WARRANTY BULLETIN

Campaign no.: 2014-0006

Subject: **Unregistered Vehicles Only**

A - Loose Windshield on RT Models

B - Gas Cap May Be Impossible To Remove

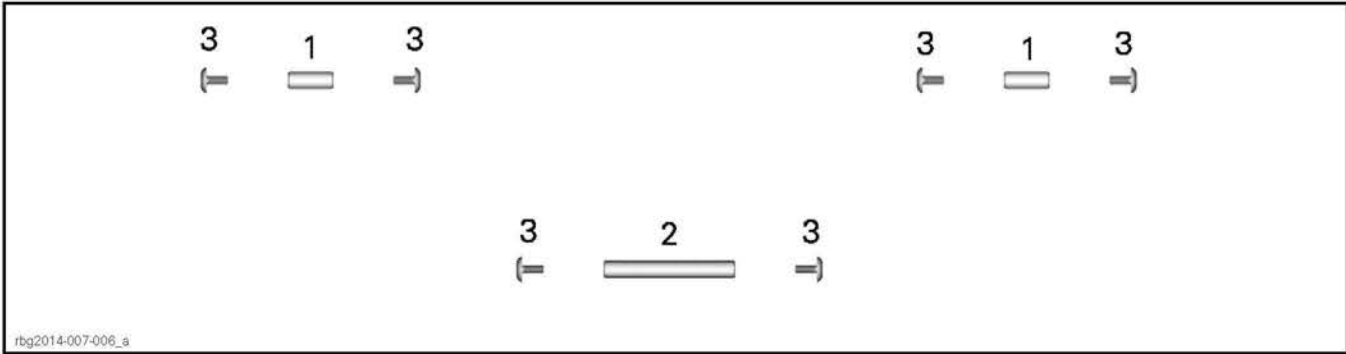
B - Gas Cap May Be Impossible To Remove

The ratcheting mechanism inside the gas cap can fail.

Replace the gas cap.

Destroy and dispose of the old gas cap as per your local regulations.

SLEEVE LOCATION
1. 21 mm (13/16 in)
2. 61 mm (2-3/8 in)

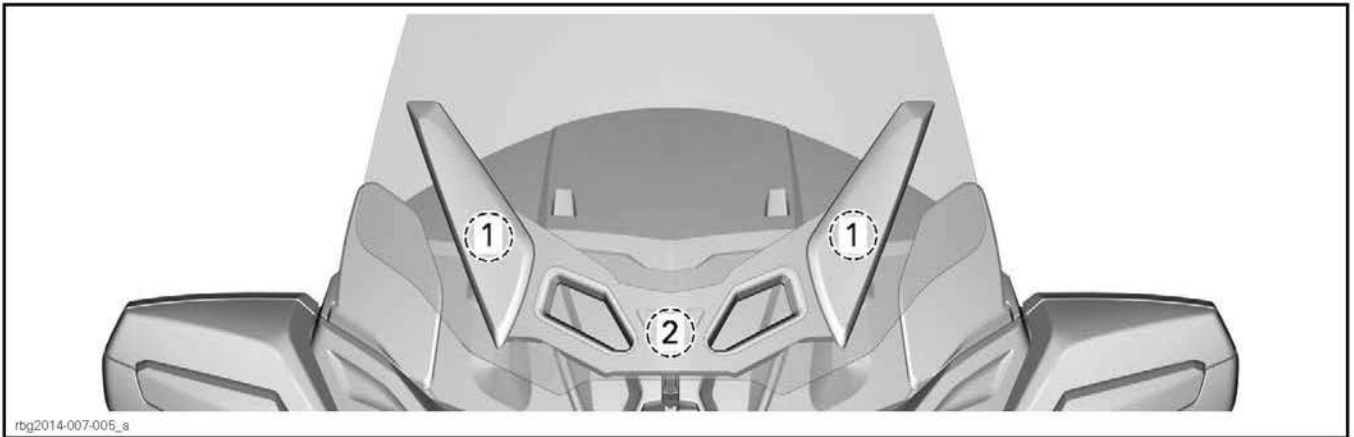
IMPORTANT

Removing all three sleeves and screws at once will result in the windshield assembly falling onto the vehicle.

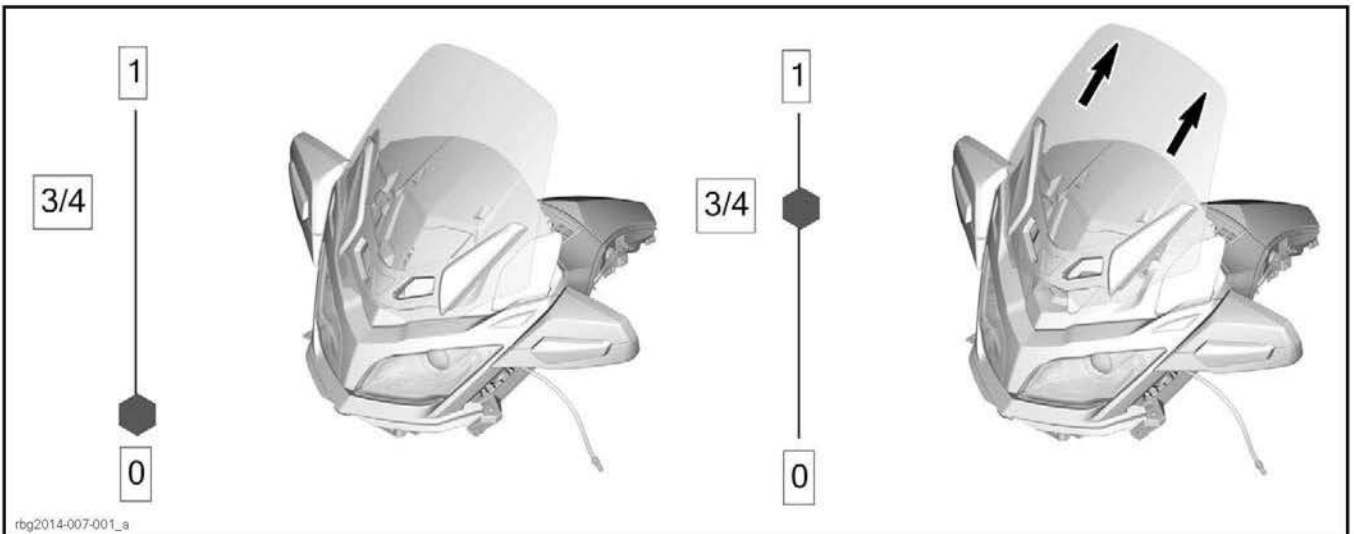
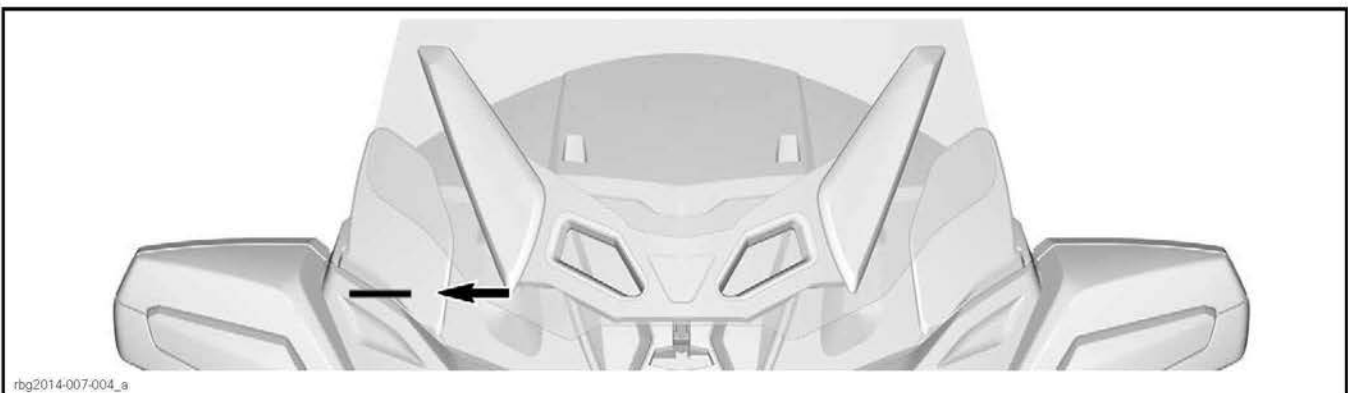
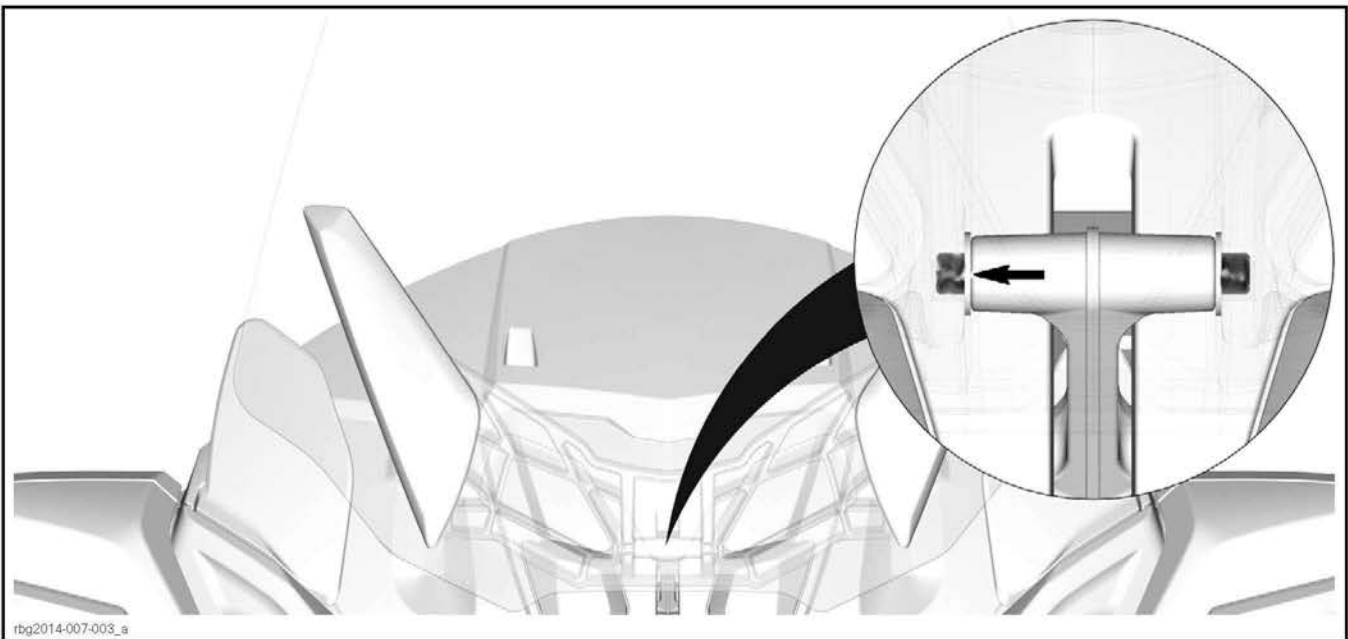
A - Loose Windshield On RT Models

One or more of the screws holding the windshield assembly may break.

1. Raise the windshield to 3/4.

2. Remove screws.

3. Remove sleeve.

4. Discard the old sleeve and screws.
5. Install appropriate sleeve and screws from the *REQUIRED PARTS*.

TIGHTENING TORQUE	
Screws	4.5 N•m ± 0.5 N•m (40 lbf•in ± 4 lbf•in)

Repeat procedure for other locations.
